ADDENDUM NUMBER TWO

**HCPS WAREHOUSE BUILDING
HENDERSON COUNTY/HENDERSON COUNTY PUBLIC SCHOOLS**

MLA PROJECT NUMBER: 21010

DATE OF ISSUE: August 25, 2021

**FLOOR PLAN &
 ELEVATIONS**

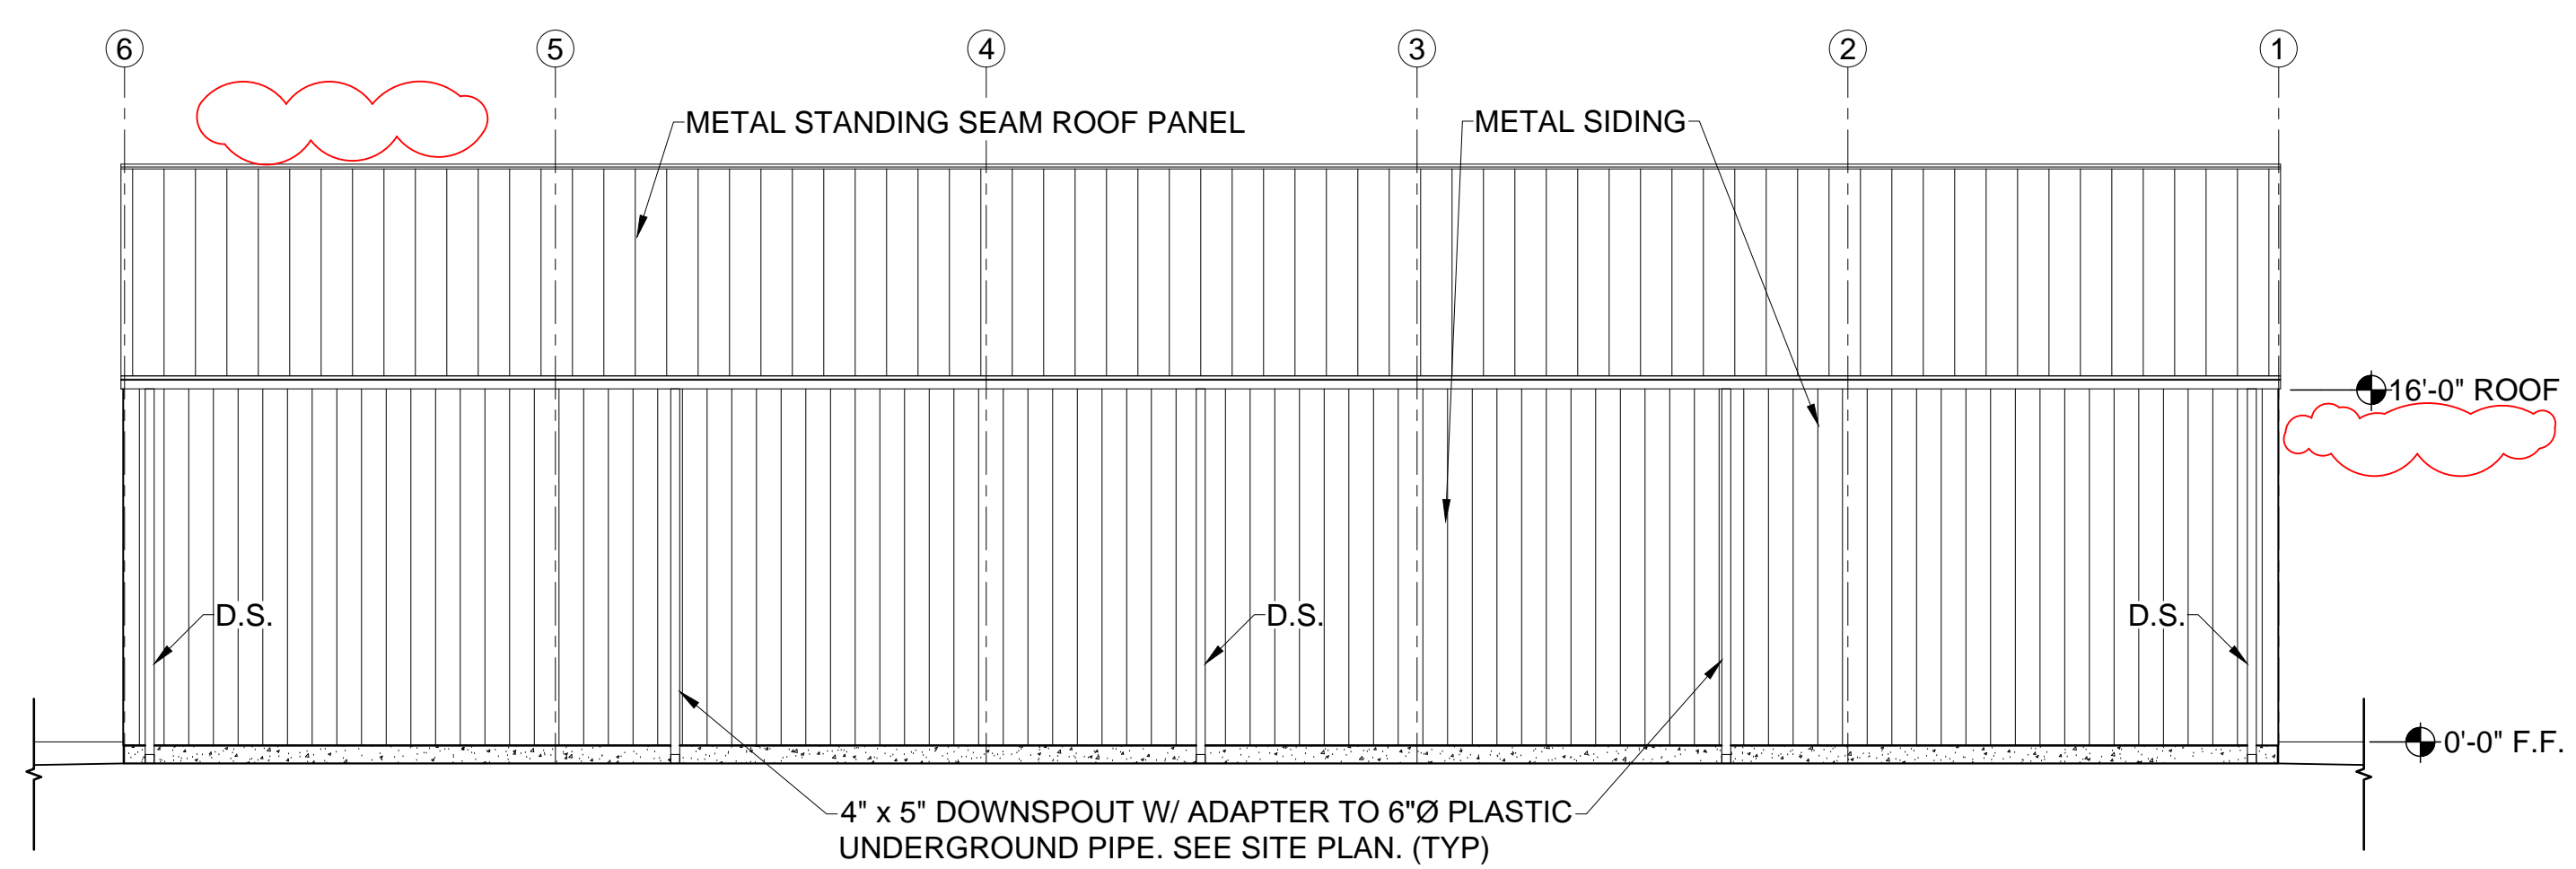
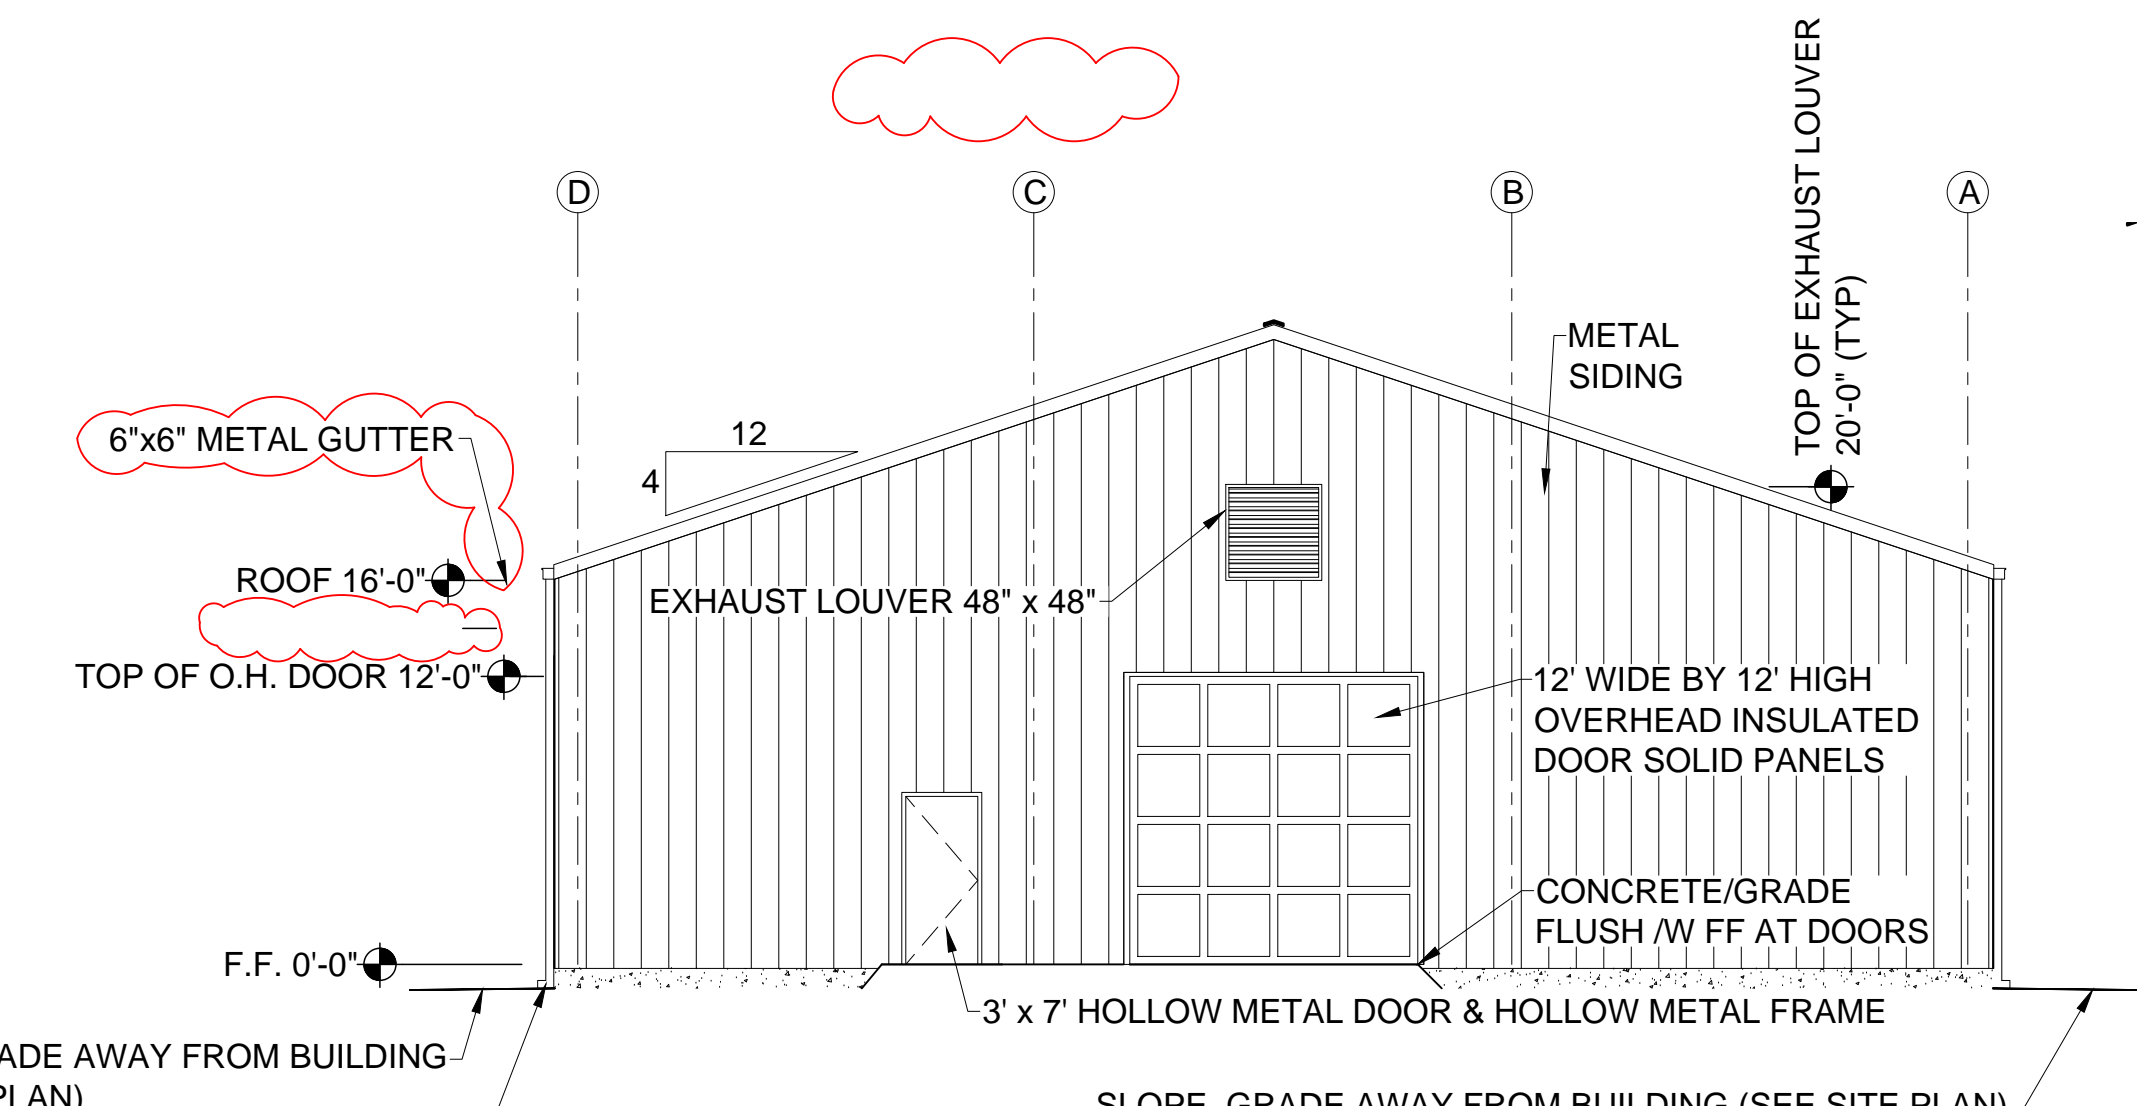
- Top soil removed for clearing is acceptable for outside fill
 - Exterior concrete clarifications and note
2. A101/ A201:
 - The soffit is deleted from the building
 - The ridge vent is deleted from the building
 - The passage door location is corrected on Alternate 1 plan
 - Concrete floor stone base thickness changed to 4"
 3. 4-5/A201: revise 6 mil VB to 10 mil VB
 4. E1/E2/ E3/ E4:
 - An exhaust fan is added to the south louvers and specified on Lighting Fixture Schedule
 - The passage door locations are corrected on Alternate 1 plan
 - The meter box and panel are re-located to the south corner wall
 - Panel A is revised to include EF's
